PLANNING AND ZONING BOARD STAFF REPORT

Delray Business Incubator

Meeting	File No.	Application Type
January 27, 2024	2023-159-SPF-SPR-LV4	Level 4 Site Plan with 1 variance & 3 waivers
Property Owner	Authorized Agent	
GS Deerfield LLC	John Tice

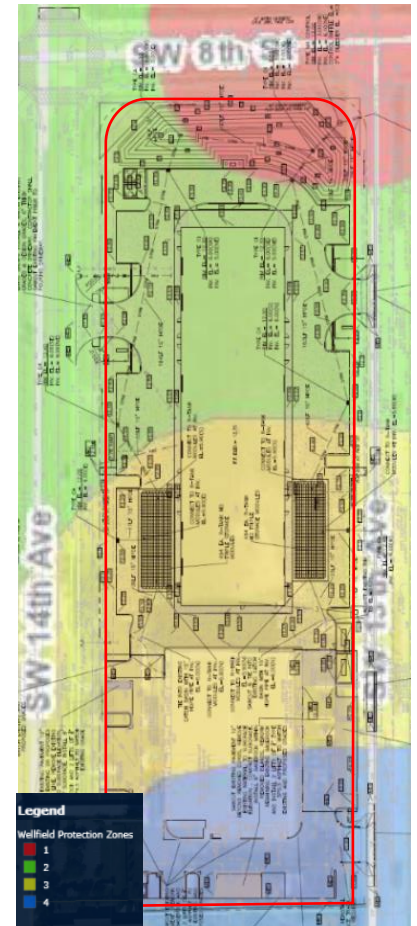
The existing well (12-17E) is located across from the subject property on SW 8th Street within Zone 1 (red). Although a portion of the subject property is located within Zone 1, the building footprint is confined to Wellfield Zone 2 (green) and Zone 3 (yellow). According to Palm Beach County Environmental Resources Management, new exfiltration systems are prohibited within Zones 1 and 2. Any future businesses that occupy the proposed warehouse, particularly those storing regulated substances, shall apply for a Wellfield Protection Operating Permit with the Palm Beach County Department of Environmental Resources Management to confirm that the use meets the requirements of the Wellfield Protection Ordinance.

The proposed exfiltration system is designed within Zone 3 (yellow), with all the catch basins and manholes located on the north side of the subject property. These will be constructed using precast concrete and are designed to prevent percolation into the groundwater. The applicant has submitted the required affidavit of notification to the Palm Beach County Environmental Resources Management, ensuring compliance with wellfield protection regulations. for further details, see the attached correspondence.

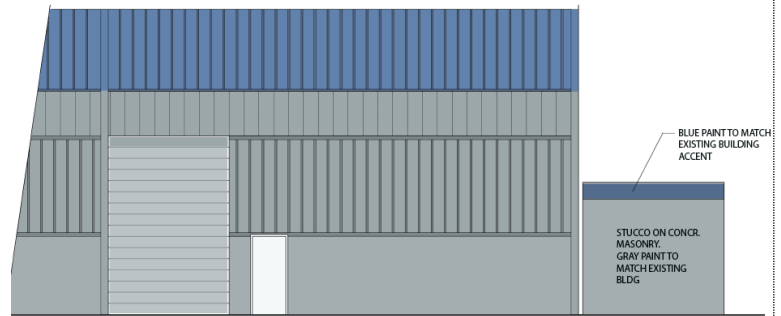
The proposed generator is located between the two buildings, north of the existing building. The generator is confined by concrete enclosure and landscape compatible with the existing Rapid Response building color (image at right).

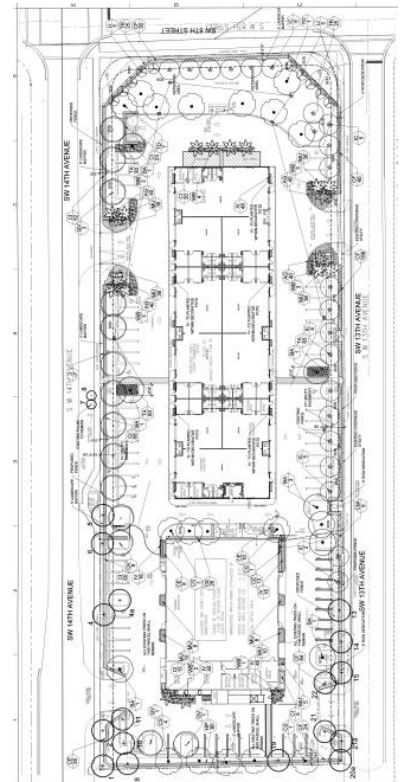
The landscaping plan for the proposed development has been evaluated for consistency with LDR Section 4.6.16. The project incorporates a lush and substantial landscape design along the perimeter of the site (image at right, and attached as full size).

At the front of the lot along SW 8th Street, a retention area is proposed, enhanced with Dahoon Holly Trees, hedges and sod, contributing to a functional and aesthetically pleasing frontage. Along the west perimeter, the design includes a 12-foot, 6 inches landscape buffer, lined with Live Oaks, hedges and sod, creating a substantial green edge.

Due to the 5-foot right-of-way (ROW) dedication along SW 13th Avenue, the previously existing 5-foot landscape buffer between the parking area and the right-of-way on the east side of the site has been eliminated, resulting in non-conformity. To address this, the applicant has included a request for a landscape waiver to reduce the buffer requirement to zero feet for the existing parking spaces along the east side (discussed in detail below). The eastern property line is not un-landscaped, however. There is a 7-foot, 7-inch-wide landscape buffer provided up to the existing parking spaces on the east perimeter, featuring Dahoon Holly Trees, hedges, and sod, to maintain continuity and greenery.

Waiver #2, Minimum Floor Area Per Tenant Bay:

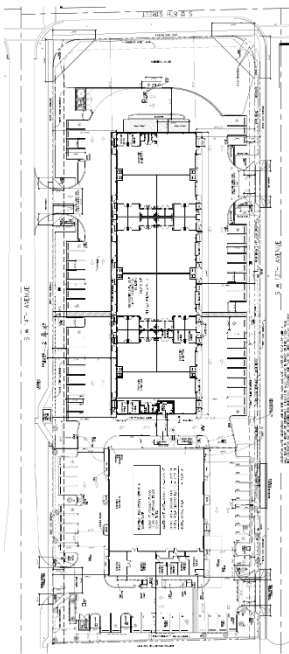
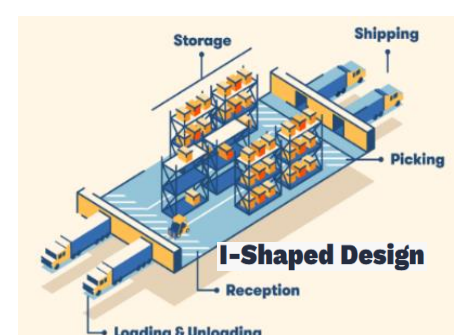
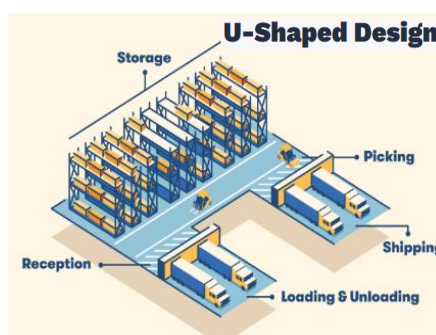
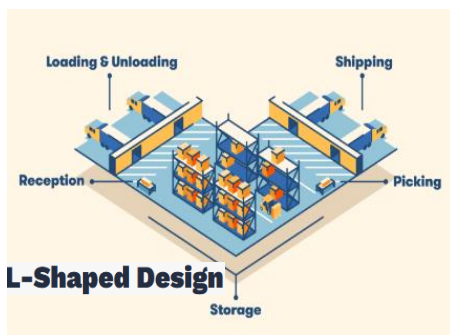
There are three common warehouse layouts, which are selected based on the unique needs of the user; U shaped, L shaped, and I shaped (images below). Typically, these warehouse layouts are for large single-tenant importers, exporters, manufacturers, and wholesalers frequently positioned in industrial parks or on the outskirts of towns or ports to allow convenient access to roads and loading docks.

The proposed development is in an “I” shape layout with 10 tenant bays with 12 total overhead doors (image at left). This style is similar to the surrounding buildings west of the property for warehouse businesses with the typical “I” shaped layout with multiple overhead doors facing the right-of-way.

Waiver #3, Required Landscape Buffer:

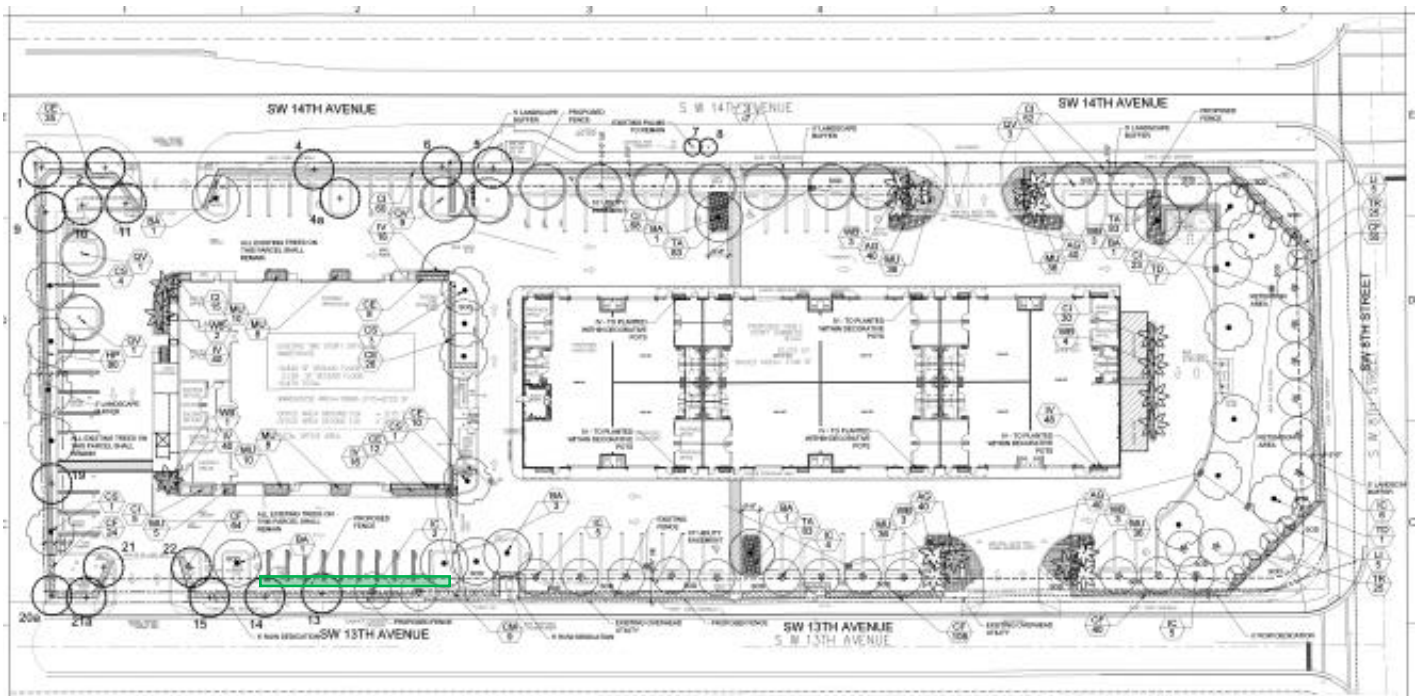
The existing 12,979 square foot, 2-story warehouse structure located at the southern portion of the parcel has existing parking spaces along SW 13th Avenue, with the required 5-foot landscape buffer. With the required 5 feet right-of-way dedication along SW 13th Avenue, the existing 5-foot landscape buffer will be reduced to 1-foot, creating a non-conformity to the parking lot design.

The applicant has requested a reduction to the required landscape buffer only along the 11 existing parking spaces on SW 13th Avenue while providing the prerequisite of a minimum 5-foot landscape buffer for the new development. The image below indicates the location of the requested waiver.
